Ref: A0123-B2-VWA-197

Re: ROSEHILL / CAMELLIA RECYCLED WATER SCHEME
Proposed Modification to Rosehill Recycled Water Scheme
Major Project Application No.: 07_0121 - As-Built Building Heights

Subject: Rosehill Recycled Water Scheme (MP 07_0121) – Mod 1

Re: ROSEHILL / CAMELLIA RECYCLED WATER SCHEME
Department of Planning Building and Tank Heights Condition 2.37

A0123-H-2000-04 [B]

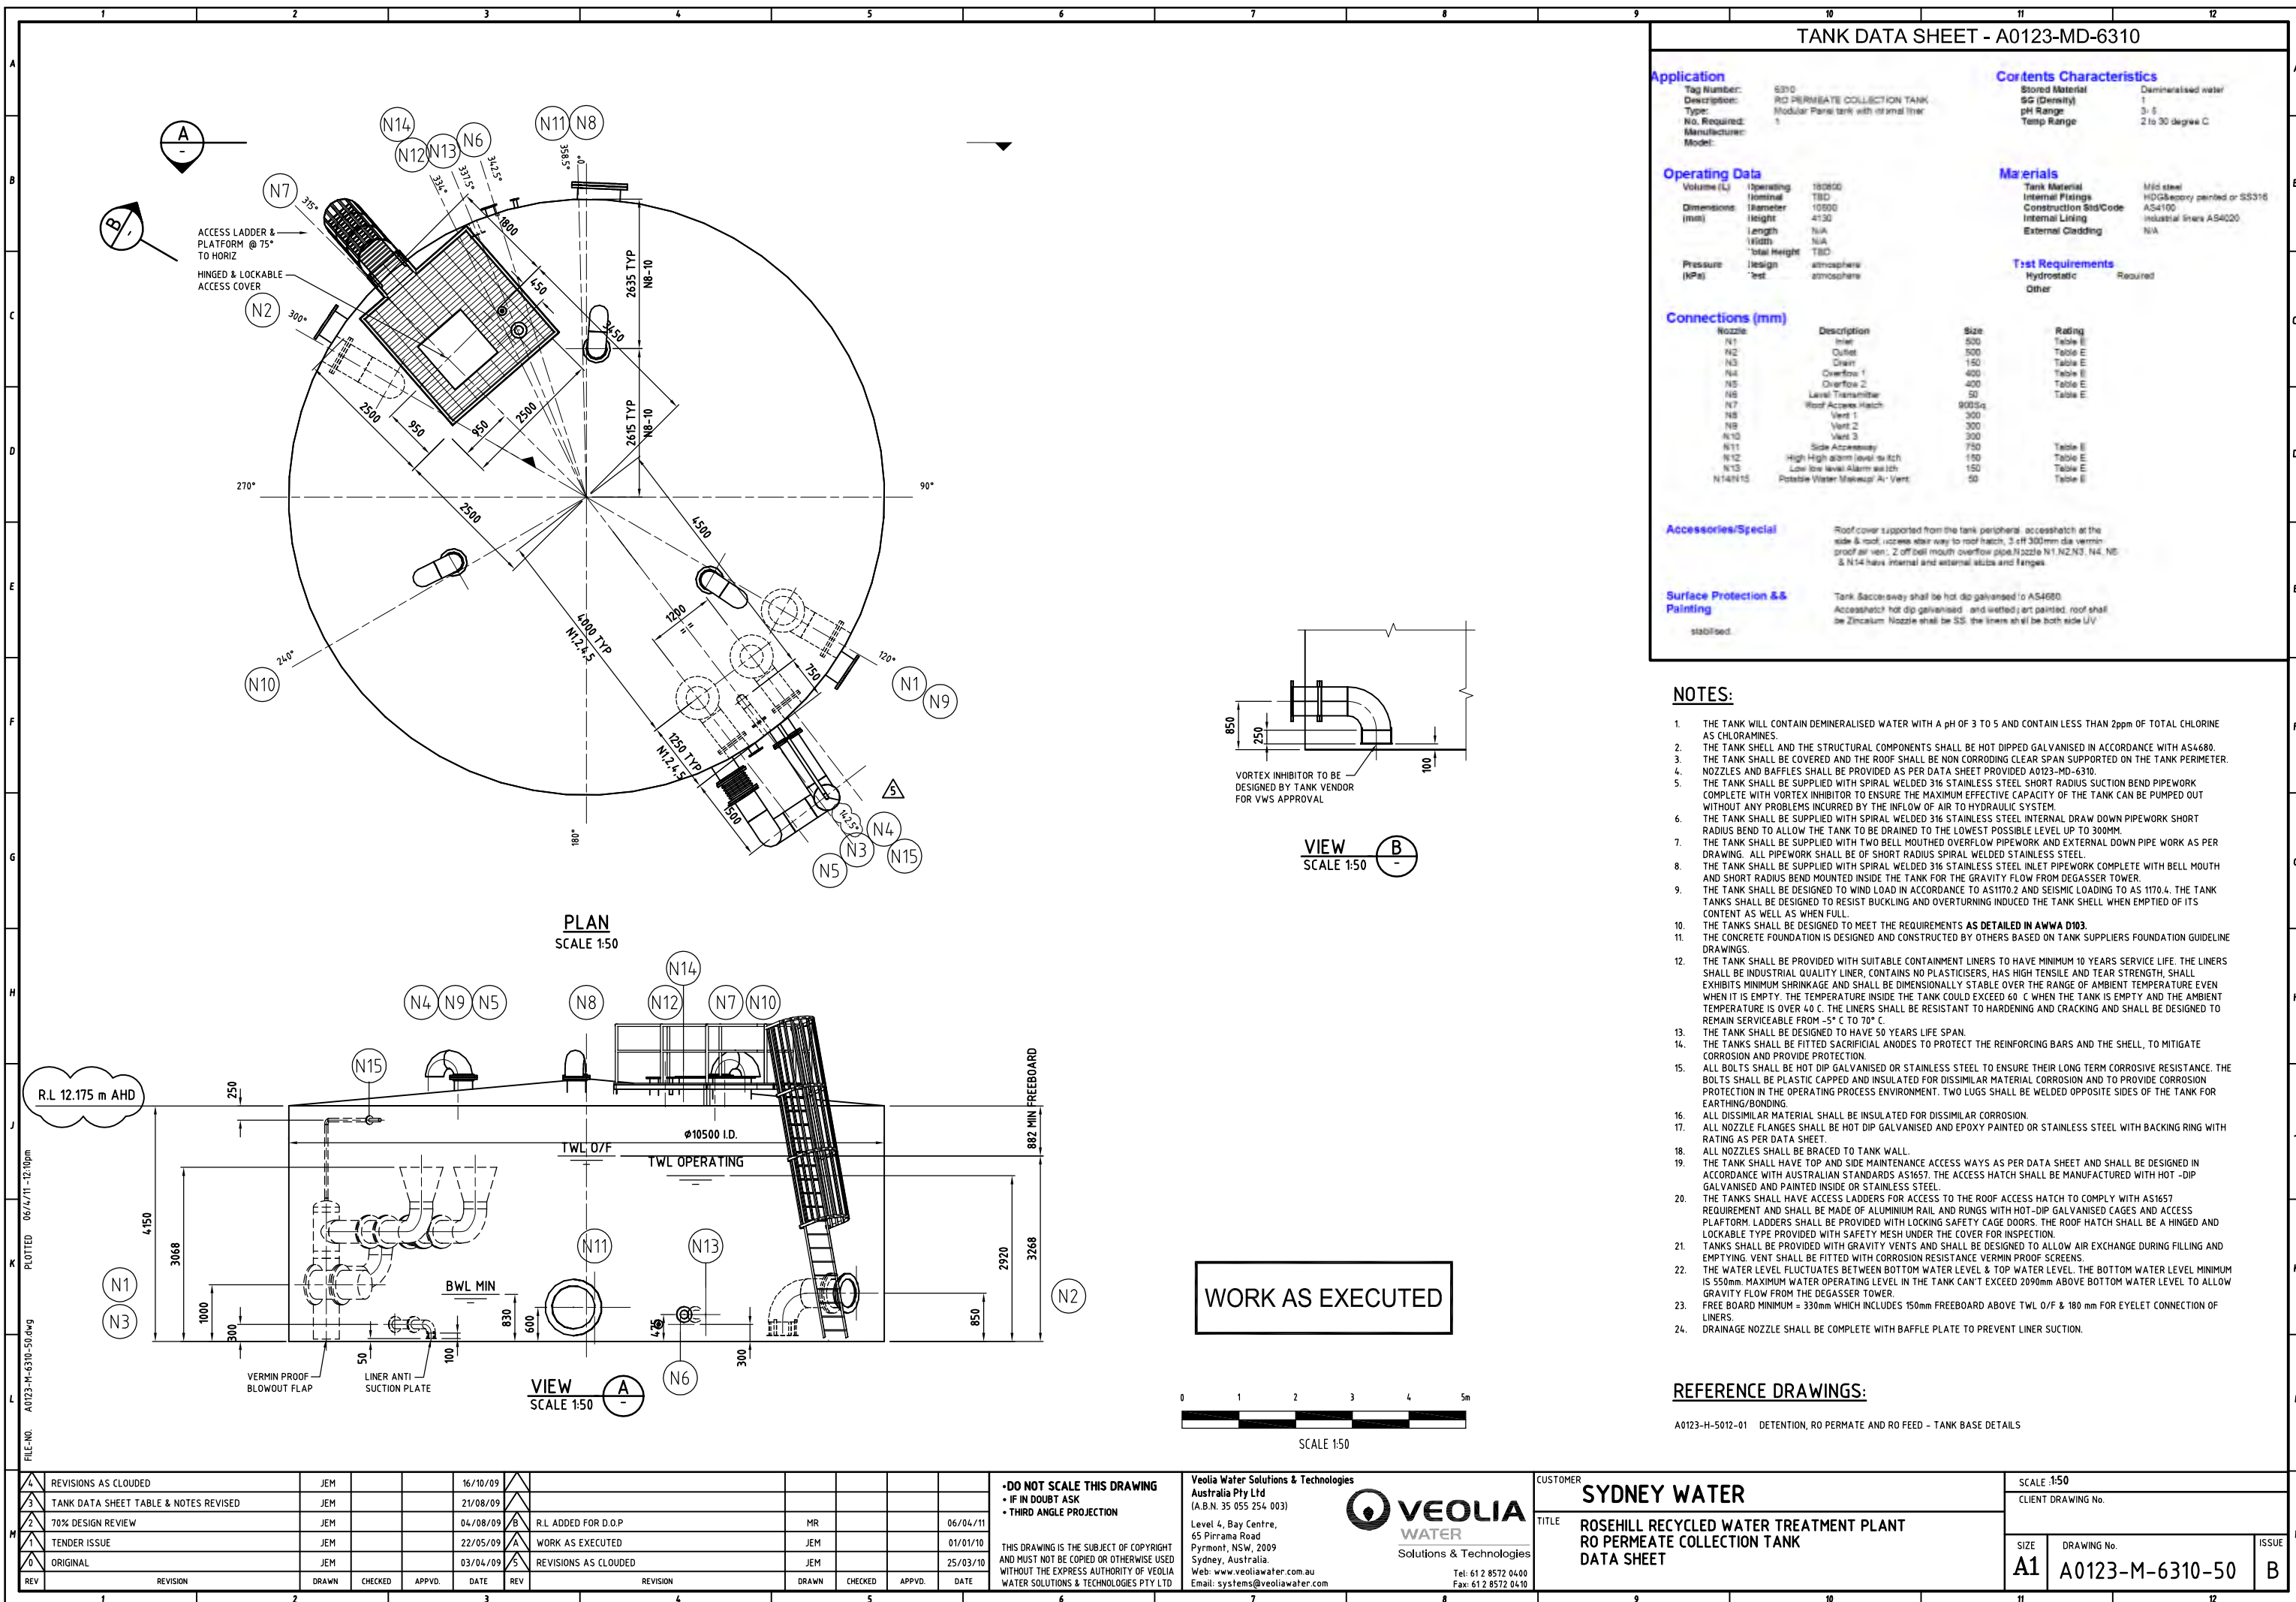
Out-of-Spec Item #3: Process Building

Reference Plans:	1. Process Building Plan View A0123-H-2000-04 Rev B1 2. Surveyors Report 9091 033 Tank Levels
Allowable Height:	18.4m
As-built Height:	18.3m (vent-pipe is 1.5m in excess of this)
Deviation:	1.5 m for the vent pipe only

The process building structure at 18.4 metres is within the limits of the DoP approval, however, a small diameter plastic (PVC) vent extraction pipe from the administration building laboratory roof is estimated to be approximately 1.5 metres higher than the DoP approval limit. This small diameter plastic vent pipe can be indentified in image 1, 2 and 3 of attachment A. When viewing the plant from North Street this small plastic vent pipe is not clearly visible.

TANK LEVELS
ROSEHILL RWTP
EAST PARADE & NORTH STREET
FAIRFIELD
NSW

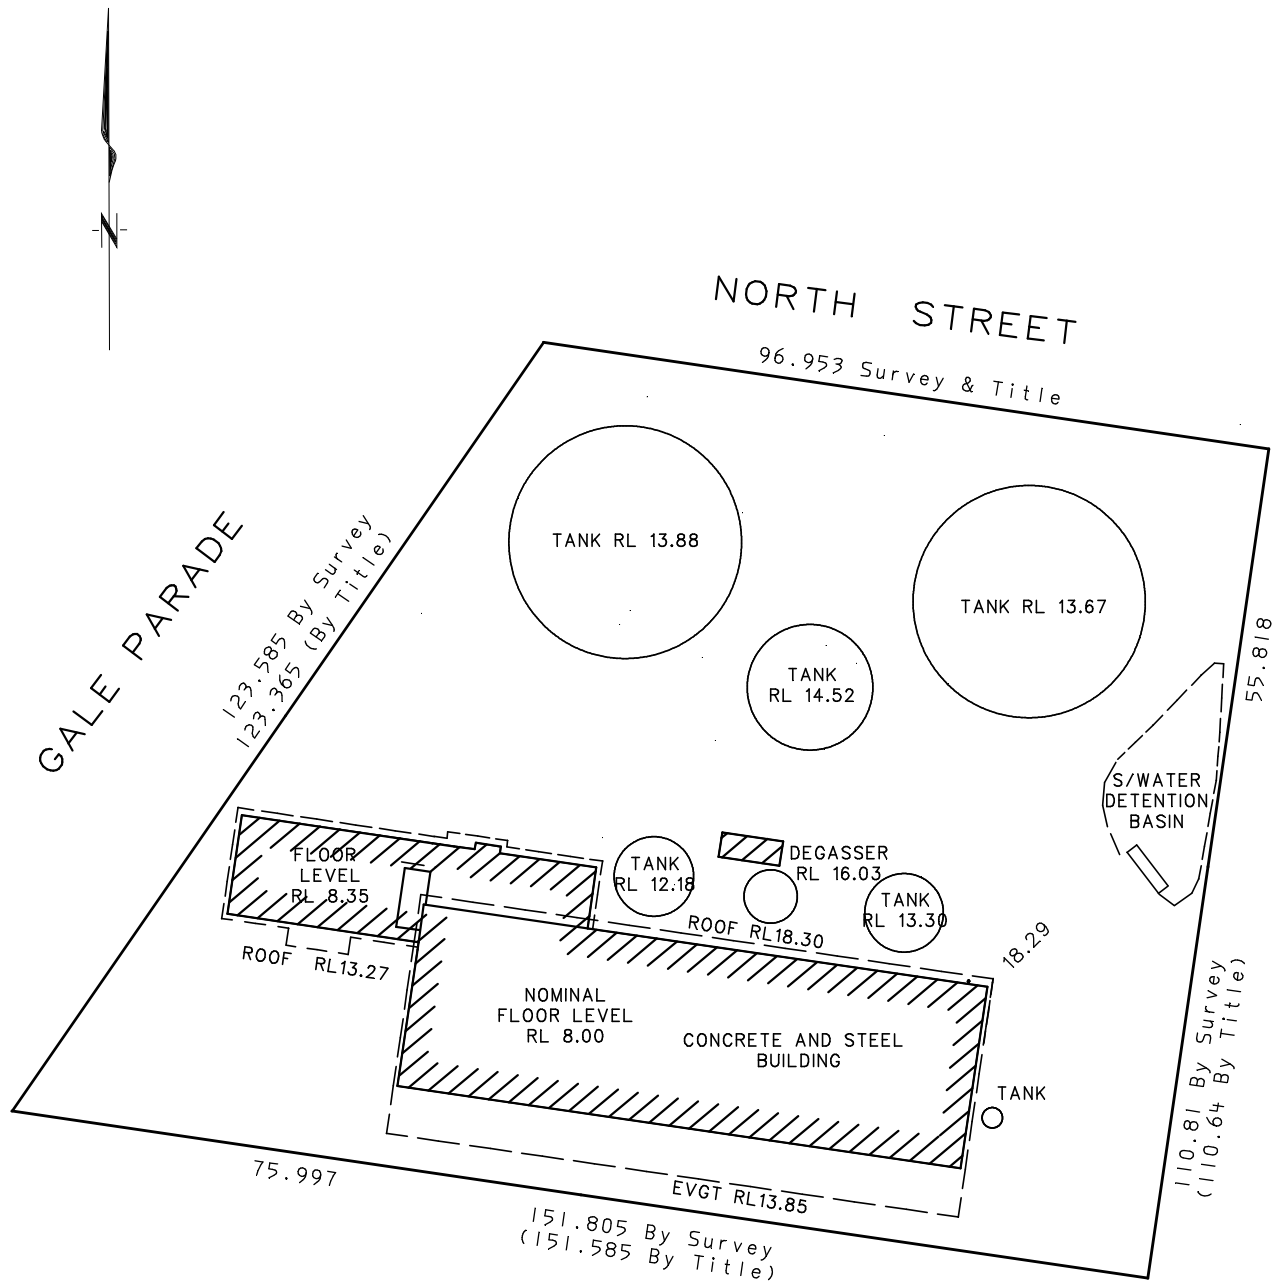
Reference Plans:	1. Degasser Plan View A0123-H-5014-03 Rev E1 2. Surveyors Report 9091 033 Tank Levels
Allowable Height:	15.9m
As-built Height:	16.03m
Deviation:	0.13m

Reference Plans:	1. Reverse Osmosis Permeate Collection Tank Plan View A0123-M-6310-50 Rev B 2. Surveyors Report 9091 033 Tank Levels
Allowable Height:	12.0m
As-built Height:	12.175m
Deviation:	0.175m
